South Texas Project Electric Generating Station P.O. Box 289 Wadsworth, Texas 77483

March 29, 2010  
U7-C-STP-NRC-100071

South Texas Project  
Units 3 and 4  
Docket Nos. 52-012 and 52-013  
Response to Request for Additional Information

**RAI 07.01-15****QUESTION:**

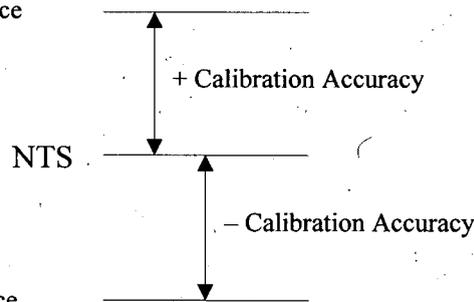
1. According to Figure 3-1 in WCAP-17119-P, the "as left" tolerance is same as the "as found" tolerance for the rack. Whereas Section 2.2, "Sensor Allowances" states that sensor calibration accuracy (SCA) is the difference between the "as left" value and the desired value, and Sensor drift (SD) is the difference between "as found" value and the "as left" value. Also as stated in Section 2.3, "Rack Allowances," rack calibration accuracy (RCA) is the difference between the "as left value and the desired value, and Rack drift (RD) is the difference between the "as found" and "as left" values. The applicant is asked to resolve the above stated discrepancies and clarify whether the "as left" value is same as the "as found" value, and also provide a description for the desired value.

Thus Figure 3-1 of the WCAP showing As Left Tolerance equal to As Found Tolerance is consistent with the statements in Section 3.3 and Section 2.3.

To clarify the differences between the As Found Tolerances in racks using the RCA term, the following clarification has been made to WCAP-17119-P Section 2.3 and also to the definitions of As Found Tolerance and Nominal Trip Setpoint in Section 3.2 of the WCAP.

The following statement has been added to the As Found Tolerance definition (underlined text):

“The “as-found” tolerance equals the instrument process rack calibration accuracy defined in the uncertainty calculation. This is based on the design premise that digital racks do not experience significant drift.”

The following statement has been added to the end of the Nominal Trip Setpoint definition:

“Evaluations of as left and as found data for analog and digital process racks suggest rack drift (RD) is significantly smaller than the procedure allowed as left tolerance. Thus, the expectation that the rack module is found within the as left tolerance, and the definition of AFT =ALT, as noted below.”
